ATTACHMENT G
CLOSURE PLAN

CLOSURE PLAN

Waste Isolation Pilot Plant
Draft Hazardous Waste Permit
 February 2018 ~~January 2016~~

Figure G-1
 Location of Underground HWDUs and Anticipated **WPC** Closure Locations

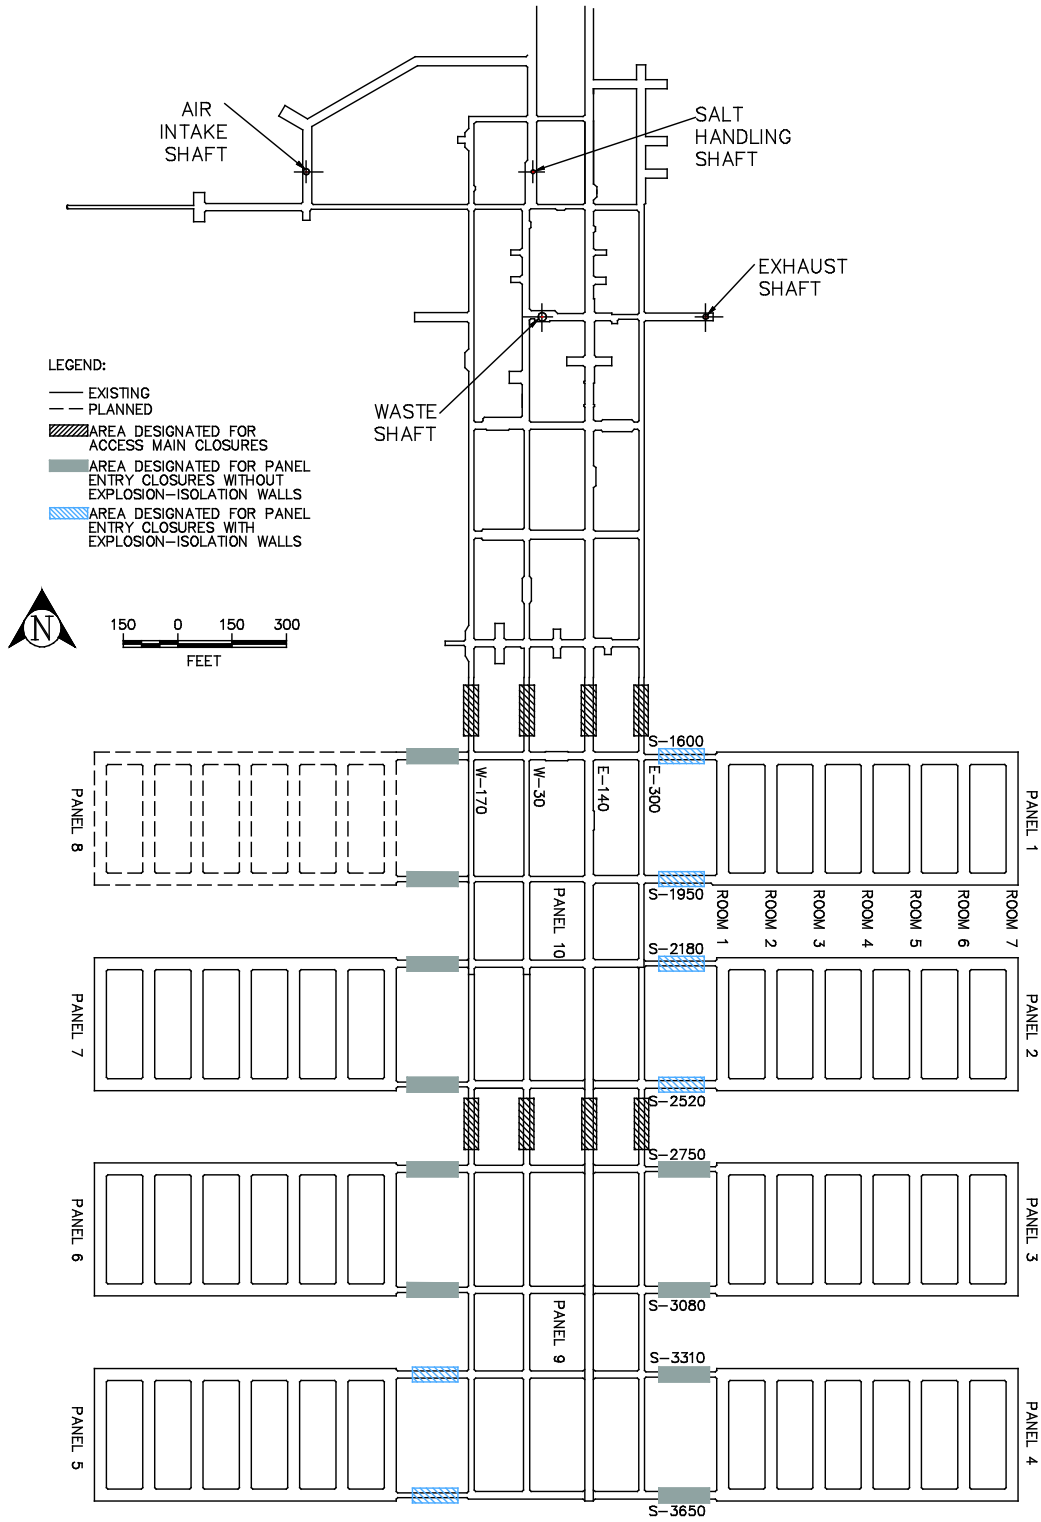
35 The maximum extent of operations during the term of this permit is expected to be Panels 1
36 through ~~108~~ as shown on Figure G-1, the WHB Container Storage Unit, and the Parking Area
37 Container Storage Unit. Note that panels 9 and 10 are not authorized for waste
38 emplacementscheduled for excavation only under this permit. If other waste management units
39 are permitted during the Disposal Phase, this Closure Plan will be revised to include the
40 additional waste management units. At any given time during disposal operations, it is possible
41 that multiple rooms may be receiving TRU mixed waste for disposal at the same time.

Figure G-3
WIPP Facility Final Closure 84-Month Schedule

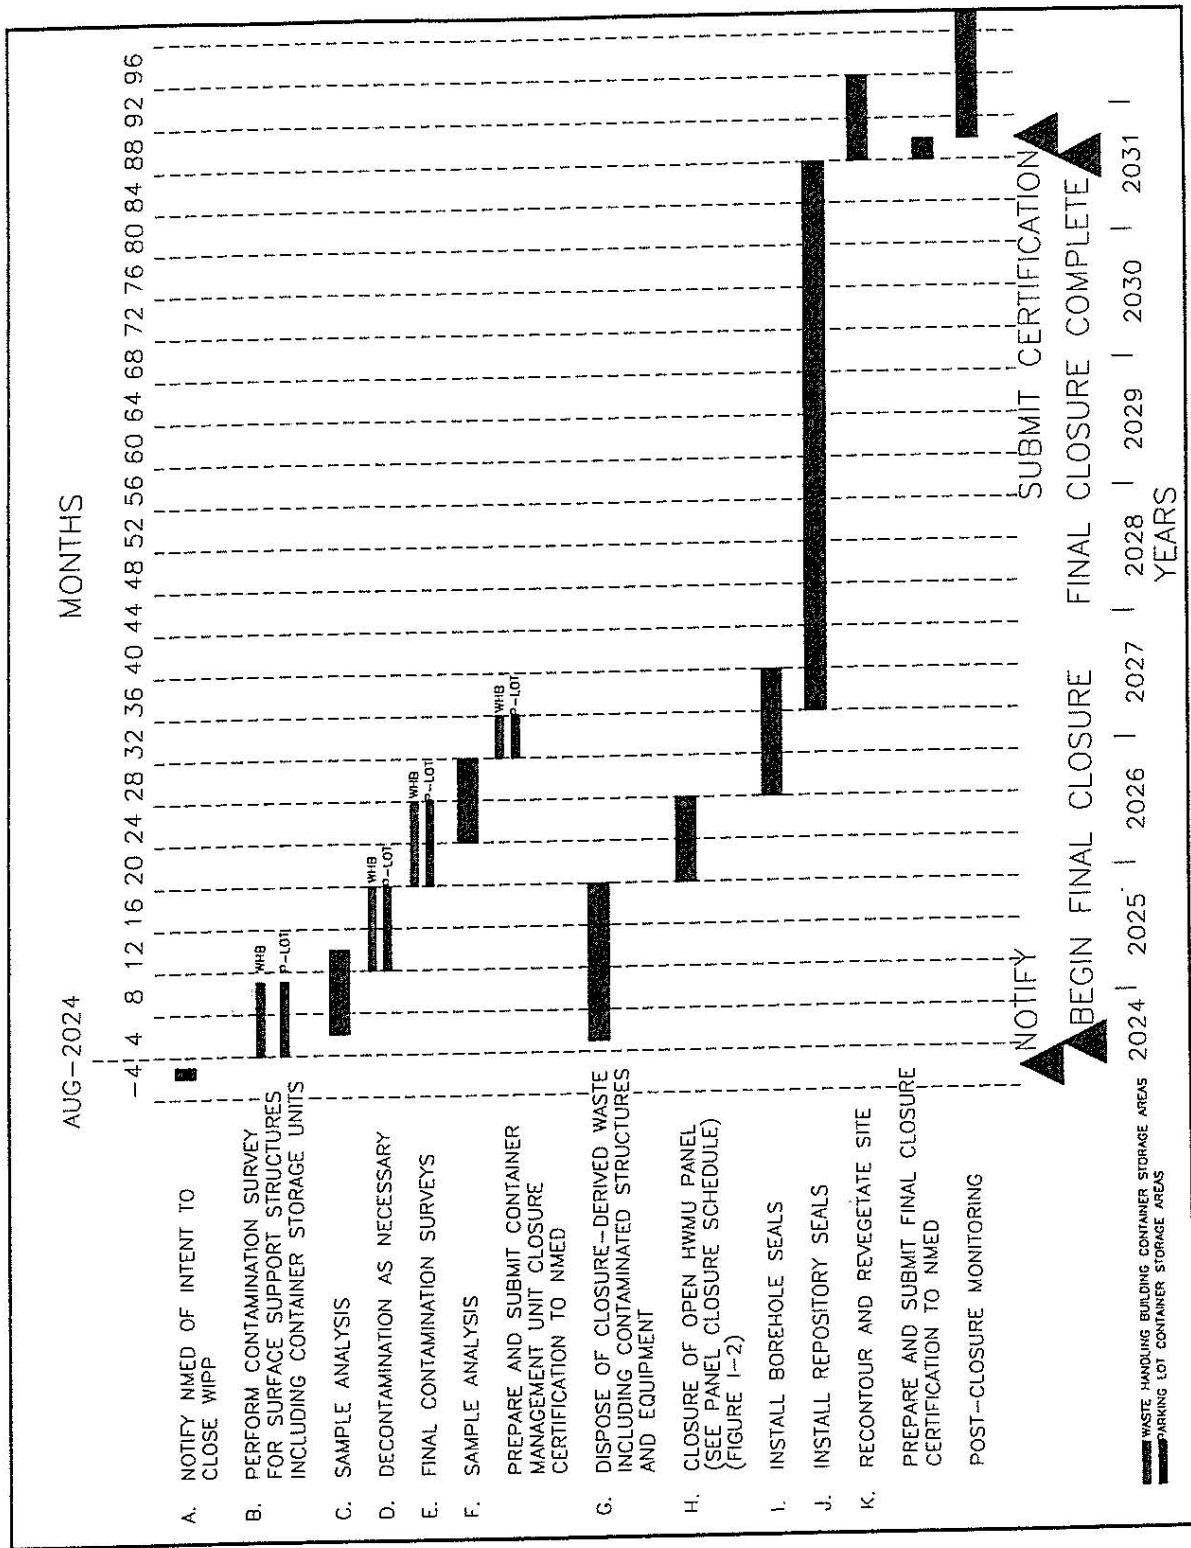
11 Resource Conservation and Recovery Act (RCRA) permit requirements. Figure G-3 presents an
12 estimate of a final facility closure schedule based on 84 months to implement final closure.

41 As indicated by the closure schedule presented in Figure G-3, the activities necessary to
42 perform facility closure of the WIPP facility ~~may will~~ require more than 180 days to complete
43 because of additional stringent requirements for managing radioactive materials. Therefore, the
44 Permit provides an extension of the 180-day final closure requirement in accordance with
45 20.4.1.500 NMAC (incorporating 40 CFR §264.113). During the extended closure period, the

Figure G-4
Bulkhead and ROM Salt Locations Design of a Panel Closure System

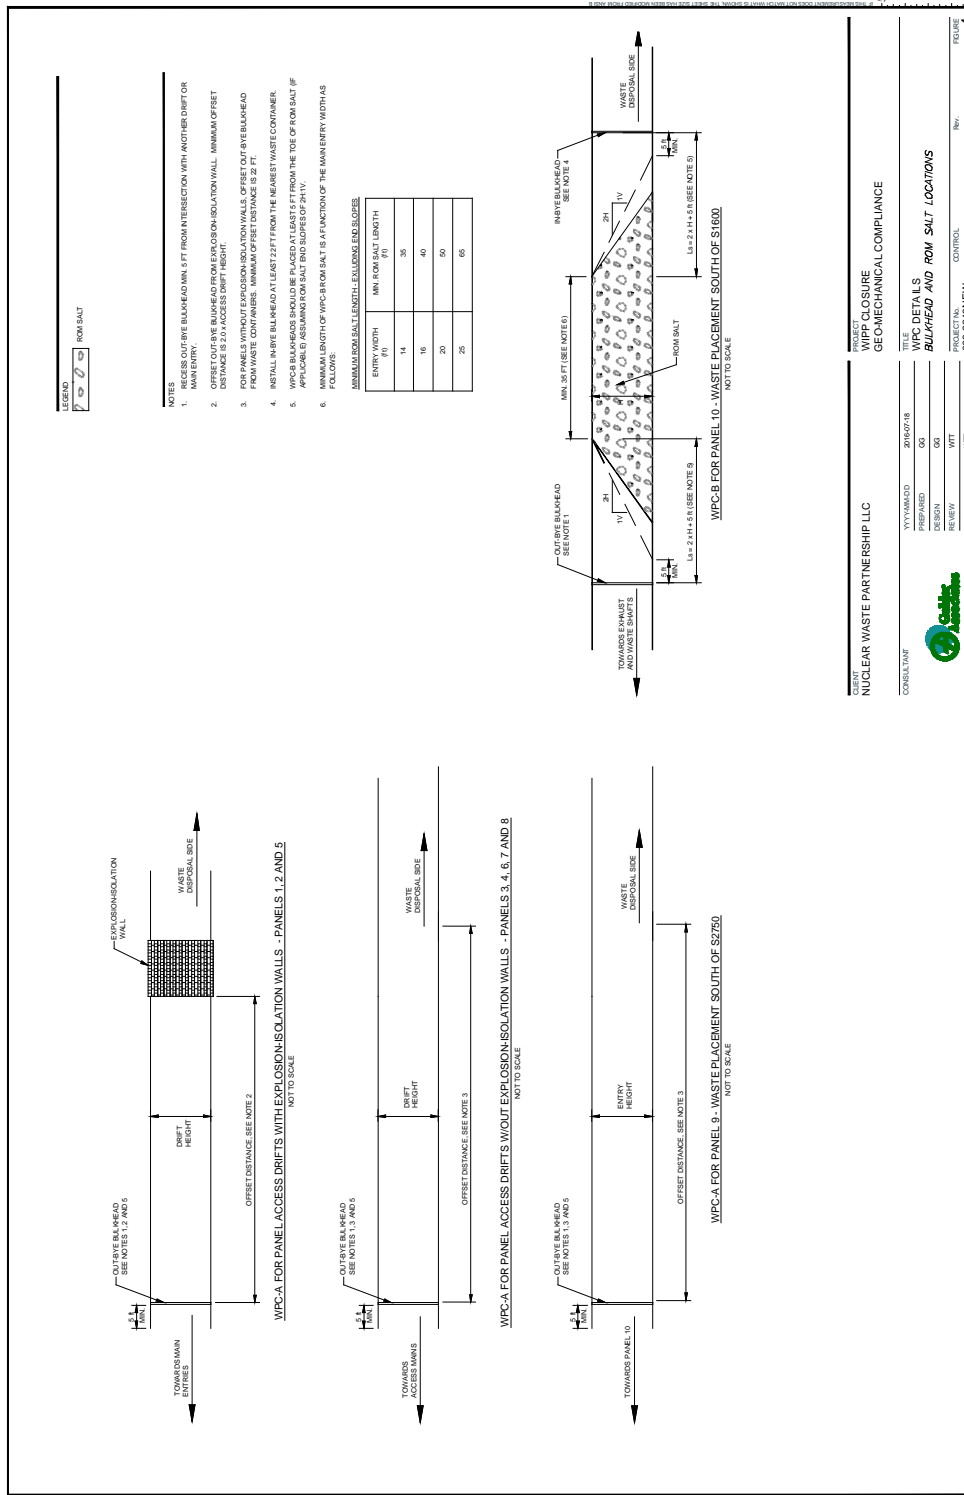
35 Figures G-4 and G-5 show a diagram of the panel closure design and installation envelopes.
36 Permit Attachment G1 provides the detailed design and the design analysis for the panel
37 closure system. ~~Although the permit application proposed several panel closure design options,~~
38 ~~depending on the gas generated by wastes and the age of the mined openings, the NMED and~~
39 ~~EPA determined that only the most robust design option (D) would be approved. This decision~~
40 ~~does not prevent the Permittees from continuing to collect data on the behavior of the wastes~~

1 ~~and mined openings, or proposing a modification to the Closure Plan in the future, using the~~
2 ~~available data to support a request for reconsideration of one or more of the original design~~
3 ~~options. If a design different from Option D as defined in Permit Attachment G1 is proposed, the~~
4 ~~appropriate permit modification will be sought. The Permittees shall use bulkheads as specified~~
5 ~~in Attachment G1 for the closure of filled panels. A run-of-mine (ROM) salt component will be~~
6 ~~included in the closure for Panel 10.~~
